Response to Editorial Comments

[Comment 1] The paper “Integration of the Vegetation Phenology Module Improves Ecohydrological Simulation by the SWAT-Carbon Model” modifies the SWAT-Carbon model to include a process-based method for estimating the start and end of the growing season based on parameterizations of environmental conditions. The paper is logically structured and provides an interesting and relevant analysis. The introduction provides a nice overview of previous research and sets up the study very nicely. The data and methods section describes the details of the experiment very well and is easy to understand. The results present an interesting analysis that compares the two model runs.

Figure S1: Temporal variability of the LAI during the calibration (2007–2011) and validation (2012–2014) periods. 8-d LAI time series observed by satellite and simulated by the original SWAT-Carbon model with adjusting non-growing season LAI for Forest (a) and grassland (b).

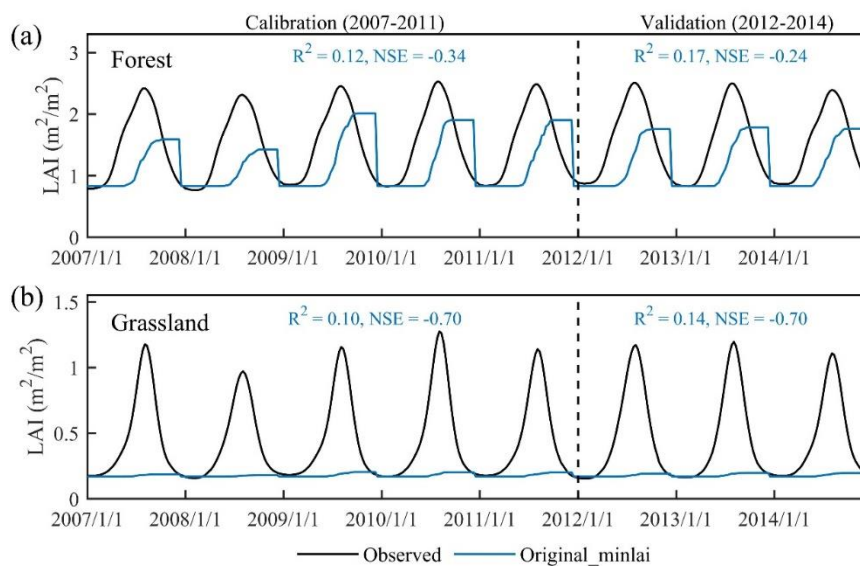
[Comment 5] Line 218 – Changing the none growing season LAI to a non-zero value greatly improved the statistics, but this should have been done for the original model too to make it a fair comparison. As is, the statistical improvement between the original and the modified is mostly due to this arbitrary choice of changing the none growing season LAI to a non-zero value and does not capture the improvement in the model's ability to estimate SOS and EOS. The improvement from the two different changes in the modified model should be carefully analyzed and discussed.

[Response 5] We thank the referee for this thoughtful comment. Following the referee's suggestion, we revised the non-growing season LAI in the original SWAT-Carbon model by adjusting the default management operation schedule and values of minimum LAI parameters (ALAI_MIN). We found that compared to the default settings, there are only slight improvements in the LAI growth curves of the original model (Figure S1). Specifically, the average NSE value improved from -1.42 to -0.29 for forests and from -1.84 to -0.70 for grasslands, which is much smaller than NSE for LAI in the modified model (0.78 for forest and 0.87 for grassland). Furthermore, we even found that the average R^2 decreased by 0.17 for forests and by 0.01 for grasslands, respectively. These results demonstrated the importance of incorporating the phenological module into the SWAT-Carbon model.

In the revised manuscript, we included these findings in the supplementary figure S1, along with additional descriptions of results and corresponding discussions:

“To further exclude the impact of non-growing season LAI, we also adjusted the non-growing season LAI to non-zero values in the original SWAT-Carbon model. The results indicated that, compared to the default settings, there were only slight improvements in the LAI growth curves in the original model (Figure S1). Specifically, the average NSE value improved from -1.42 to -0.29 for forest and from -1.84 to -0.70 for grassland, which is much smaller than NSE for LAI in the modified model. Furthermore, the average R^2 decreased by 0.17 for forest and by 0.01 for grassland, respectively.” (Lines

Figure 7: Relationship between the phenological variations and sub-basin scales evapotranspiration (ET) using modified SWAT-Carbon model. GSL, growing season length; SOS, start-of-season; EOS, end-of-season; ET, evapotranspiration.

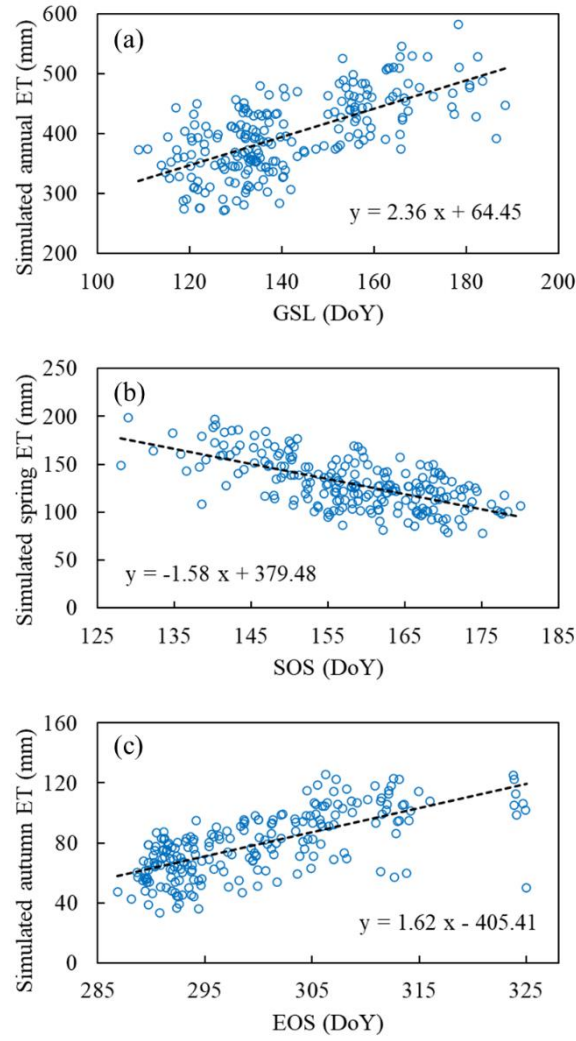
[Comment 8] Line 275: This discussion section also needs revisions. When does the analysis show “a positive correlation between ET and growing season length”? If the figures in supplementary material are so important that they are worth discussing in the discussion section, then they should probably be included in the paper

[Response 8] We thank the referee for this comment. Following referee’s suggestion, we incorporated the figure S2 into the section 4.2 of the paper and updated the corresponding text in the revised manuscript:

“In addition, the vegetation dynamics and their impact on the underlying land surface properties affect watershed evapotranspiration (Chen et al., 2022b). To explore the response of ET to vegetation phenology in the upper reaches of Jinsha River watershed, we analyzed the relationship between the phenological variations and sub-basin scale ET using the modified SWAT-Carbon model. Consistent with previous studies in the Northern Hemisphere, our study revealed a positive correlation between ET and growing season length (Figure 7), potentially attributed to the prolonged period of water movement from the soil to the atmosphere (Geng et al., 2020; Yang et al., 2023).” (Lines 318-323)

Figure S3: Projection of average future runoff from 2030 to 2100 under each emission scenario simulated by the modified SWAT-Carbon model and CMIP6.

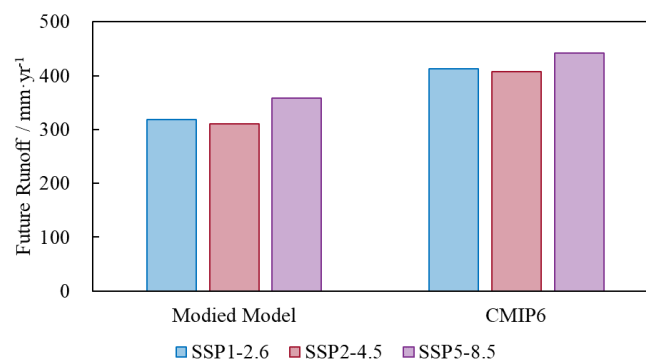
[Comment 4] Line 250: Future runoff changes simulated by the modified SWAT-Carbon model could be compared not only with those simulated by the original SWAT-Carbon model but also with runoff directly provided by CMIP6.

[Response 4] Following the referee's comment, we added a comparison of future runoff simulated by the modified SWAT-Carbon model with those directly provided by CMIP6. We found that the average future runoffs obtained from CMIP6 models was larger than that simulated by the modified SWAT-Carbon model (please see the Fig. S3 below and the revised manuscript). In the revised manuscript, we incorporated these findings in the results as:

“Monthly total runoff outputs were obtained from CMIP6 models and aggregated to annual runoff from 2030 to 2100. We calculated the watershed-scale future runoff from CMIP6 using the area-weighted mean method and found that the future runoff from CMIP6 models was larger than that simulated by the modified SWAT-Carbon model (Figure S3).” (Lines 273-276)

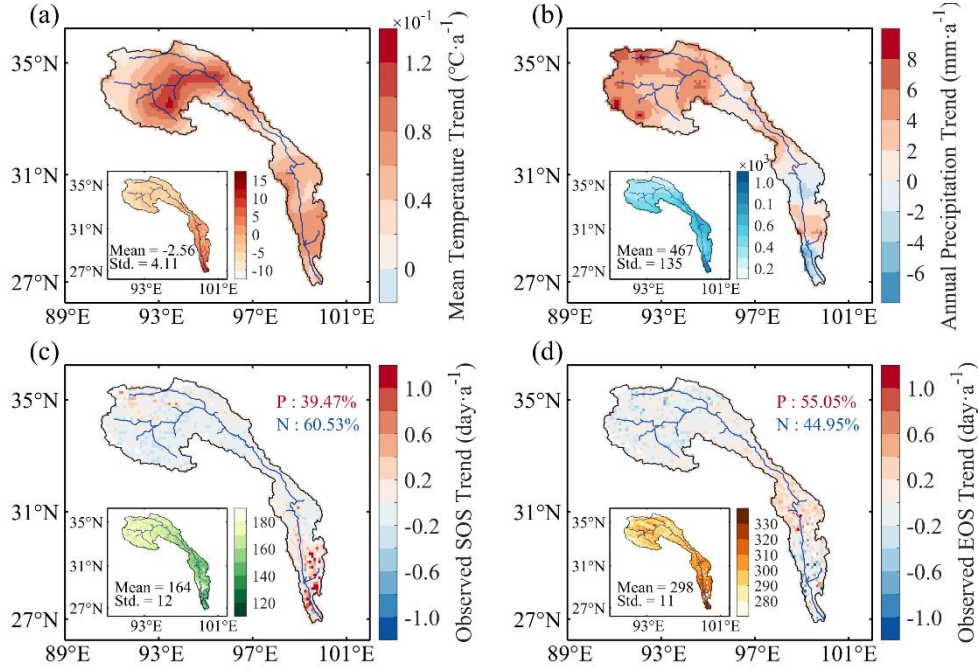
[Comment 5] Figure 2: The information (e.g., abbreviations) in the figures should be clearly interpreted in the figure caption.

[Response 5] Following the referee's comment, we improved the caption of Figure 2.

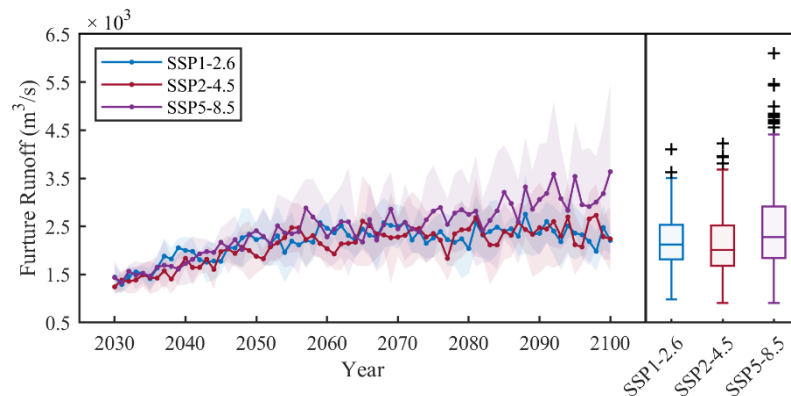
[Comment 6] Figure 6: These times series should include shading to represent the uncertainty, as shown in Figure 5?

[Response 6] Following the referee's comment, we incorporated shading into Figure 6 to represent the uncertainty across the four CMIP6 models under each emission scenario.
